Subject: Dresden and Quad-Cities Stations  
Proposed Change to Eliminate License  
Requirements for Jet Pump Flow Indication  
from DPR-19, DPR-25, DPR-29, and DPR-30.  
NRC Docket Nos. 50-237, 50-249, 50-254,  
and 50-265

RESPONSE TO REQUEST FOR ADDITIONAL INFORMATION

PROPOSED CHANGE TO TECHNICAL SPECIFICATIONS TO  
DELETE REQUIREMENTS FOR JET PUMP FLOW INDICATION

OCNPS UNIT 1  
 CHARACTERISTIC CURVE OF  
 CORE PLATE  $\Delta P$  VERSUS CORE FLOW  
 FIGURE 4-1

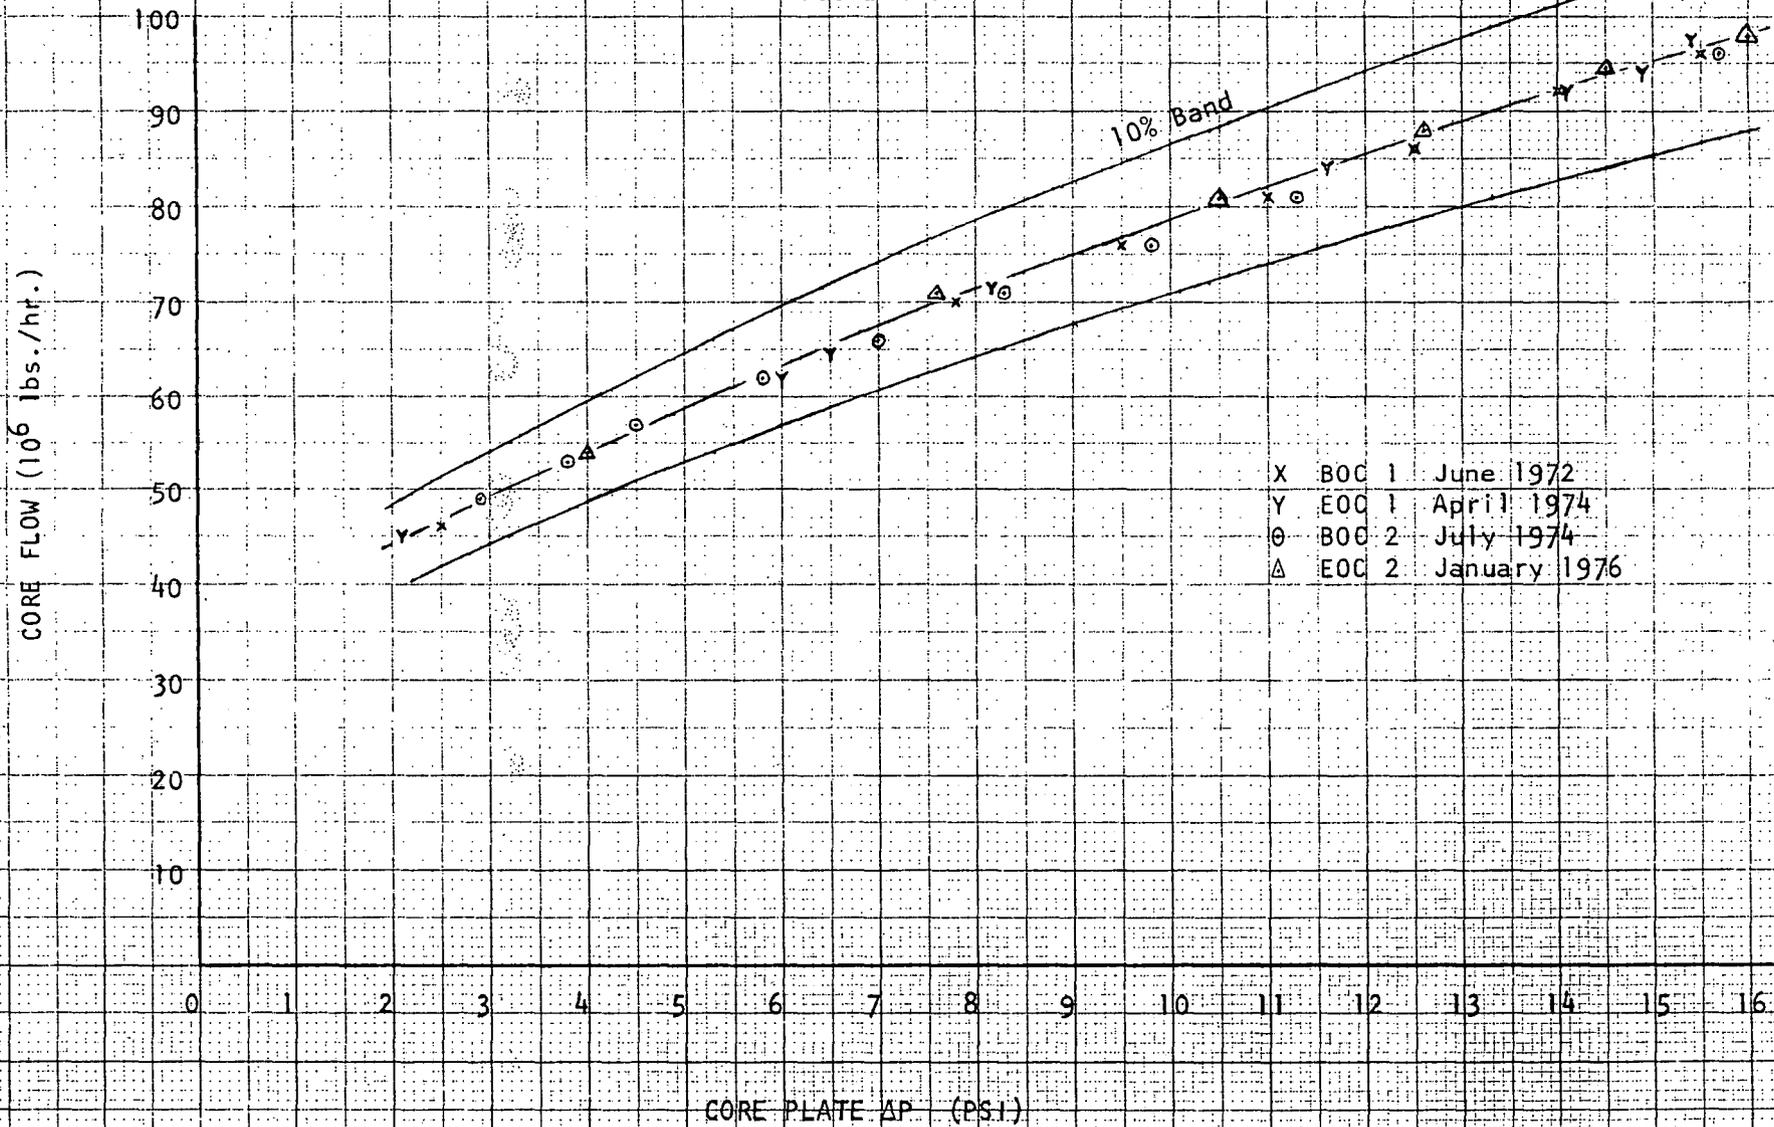
ITEM 4: Provide data concerning initial and recurrent calibration of the differential pressure instrument(s) which measure(s) across the core plate at Quad-Cities Unit 1. Numerical data related to instrument drift as a function of time is desirable.

From the calibration data that is available, this instrument and others of the same model type have experienced only minimal drift on the order of less than 1% since their initial calibration. Data is available from June, 1972 through January, 1976 that illustrates the total core flow as a function of core plate  $\Delta P$ . This data is graphically shown in Figure 4-1. It can be seen that the core plate  $\Delta P$  has been within approximately 3% of the characteristic curve with the variations primarily due to minor inconsistencies in data-taking. Instrument drifts of 1% or less are probably masked by the accuracy of the data takers.

The characteristic curve in Figure 4-1 is typical of the curve that would be used to verify the total core flow indication according to proposed Technical Specification 4.6.B.1.b. The actual characteristic curve to be used for the required surveillance would be re-evaluated each operating cycle in accordance with Technical Specification 4.6.G.3.

As shown on Figure 6.1, a jet pump failure would be easily determined by use of this curve. It is felt that a calibration frequency of once per operating cycle will adequately insure the accuracy necessary for operational use of this instrument.

Jet Pump Flow Distribution  
Figure 5-1

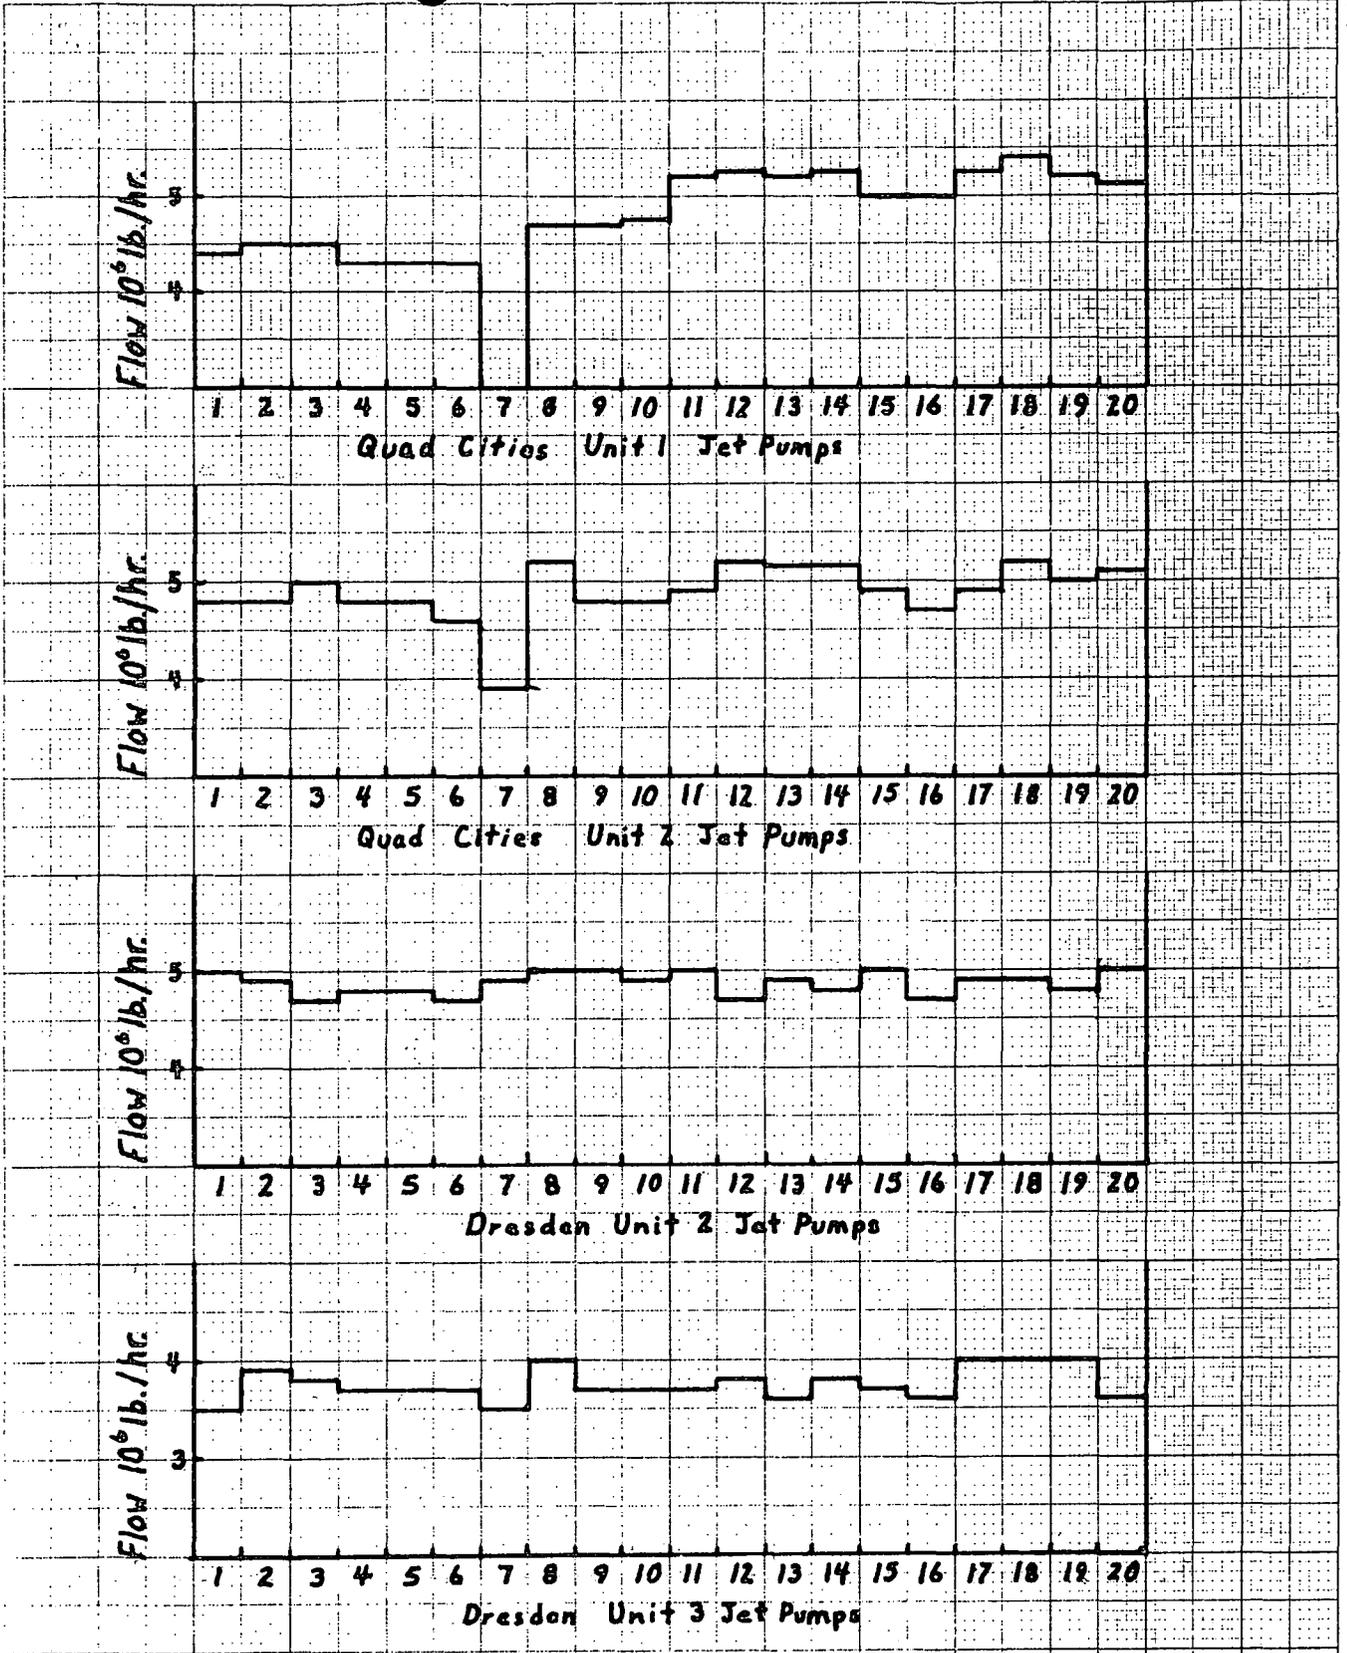
ITEM 5: Provide the latest flow readings (at  $\approx$  100% power) of all jet pumps for all stations. Provide data in same format as figure C.10-4 on C-93/C-94 of NEDC-10692 (Startup Test Results, Dresden Nuclear Power Station Unit 3, January 1, 1971-November 16, 1971) and include actual value recorded. A copy of figure C.10-4 is enclosed. This data will be utilized in the analysis of jet pump performance at other stations.

RESPONSE: The subject jet pump flow readings are shown in Figure 5-1 in the format requested. The actual flow values plotted on the graphs are shown in Table 5-1. The values shown are from the last set of calibration data obtained in accordance with Technical Specification 4.6.G.3.

FIGURE 6-2  
2A RECIRC PUMP CHARACTERISTIC CURVE  
TWO PUMP OPERATION CYCLE I

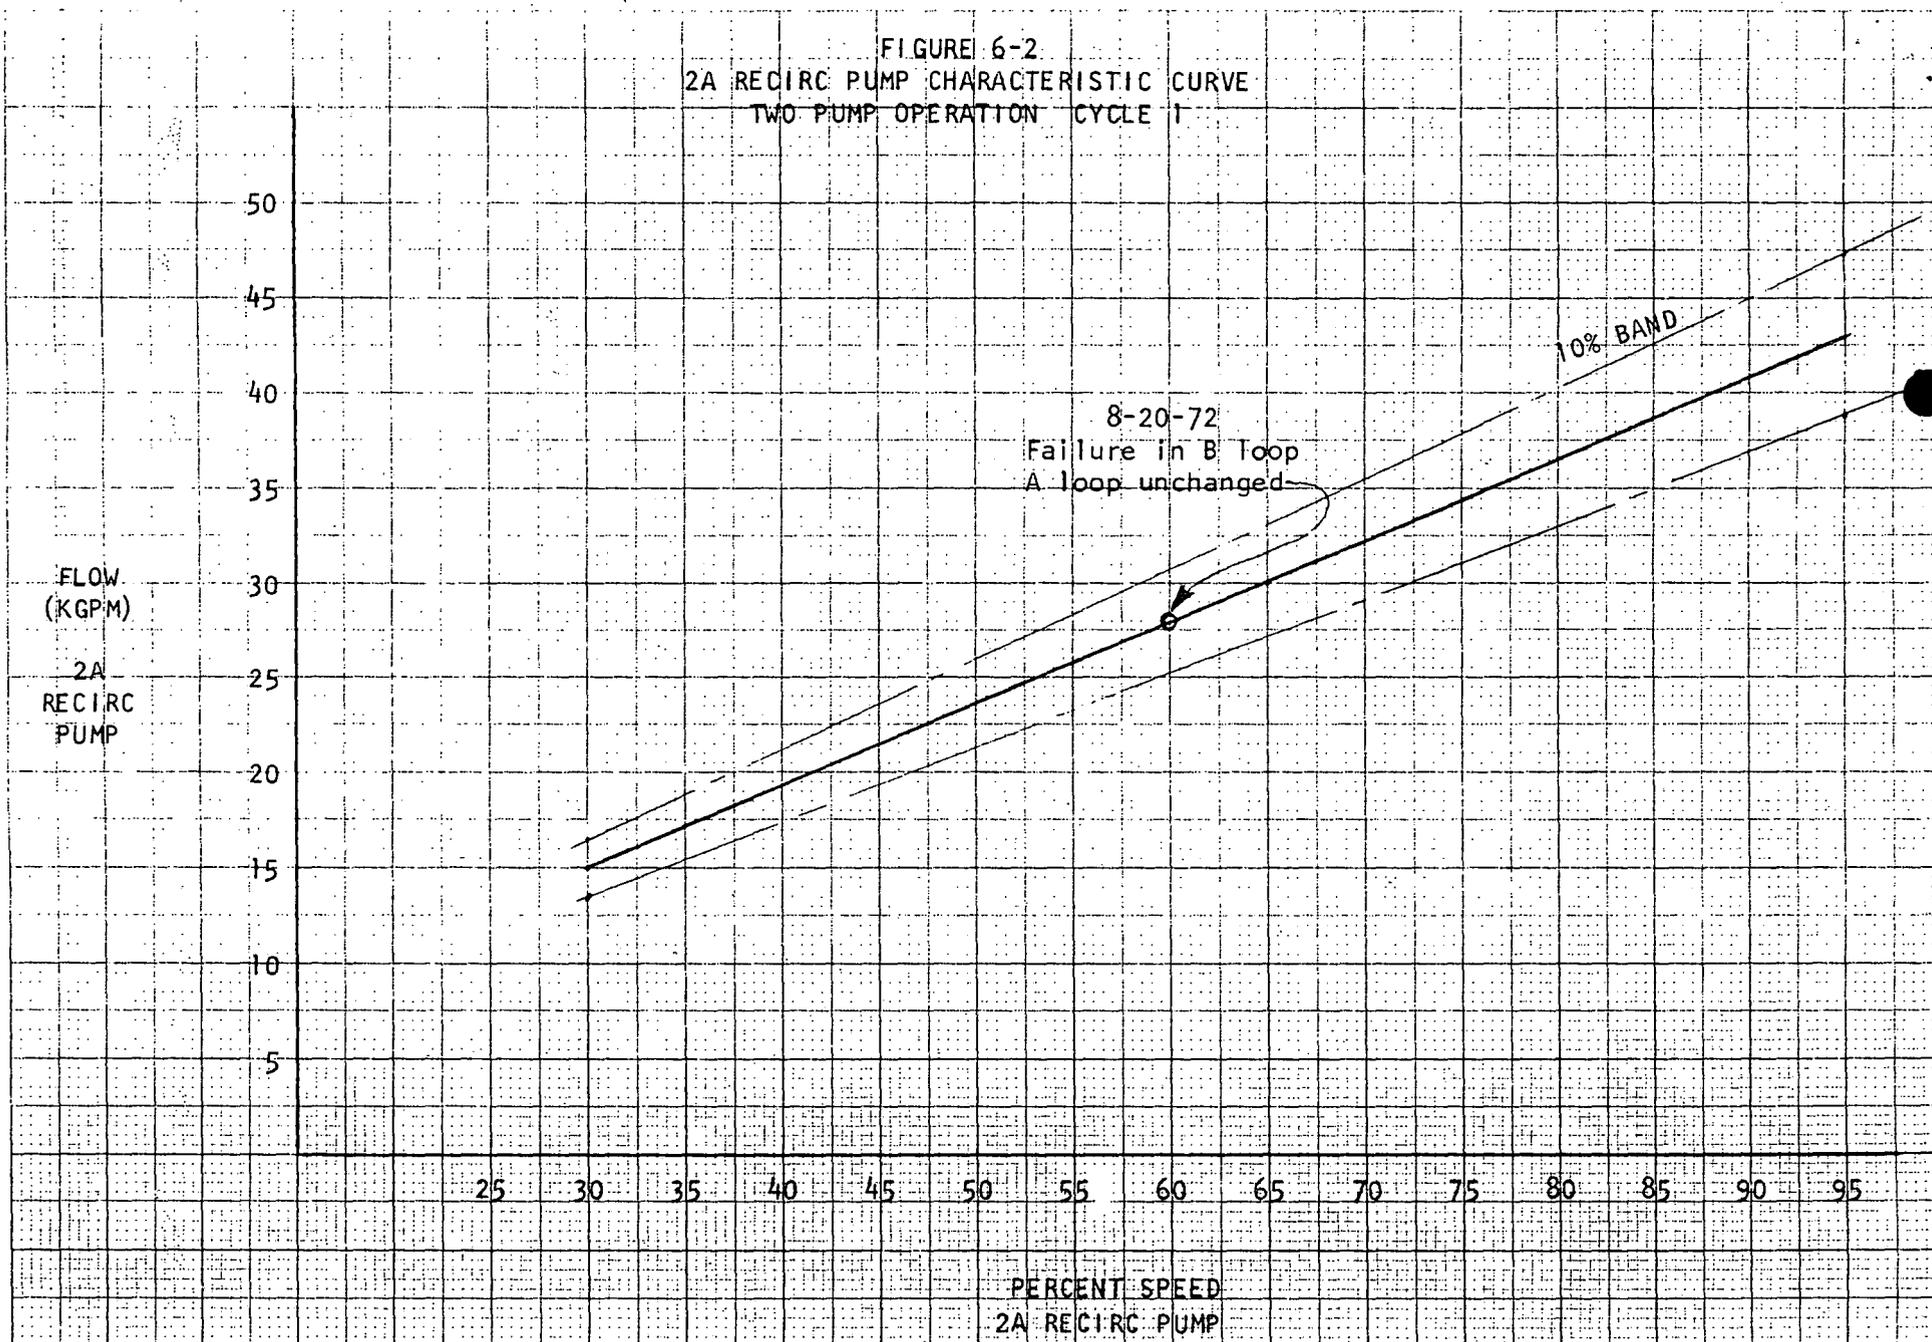
ITEM 6: Discuss the conservatism of the 10% value of Technical Specifications 4.6.G.1.a and b, especially with reference to instrument calibration and error and changes in pump speed-flow characteristics with age.

Figure 6-2 shows that the recirculation flow characteristic remains unchanged in the loop that remains intact. Figure 6-3 shows that the recirculation flow characteristic for the affected loop increases by greater than 10% for the same pump speed signal. These curves are utilized to perform surveillance according to Technical Specification 4.6.G.1.a and thus give a positive indication of a change in reactor flow system performance.
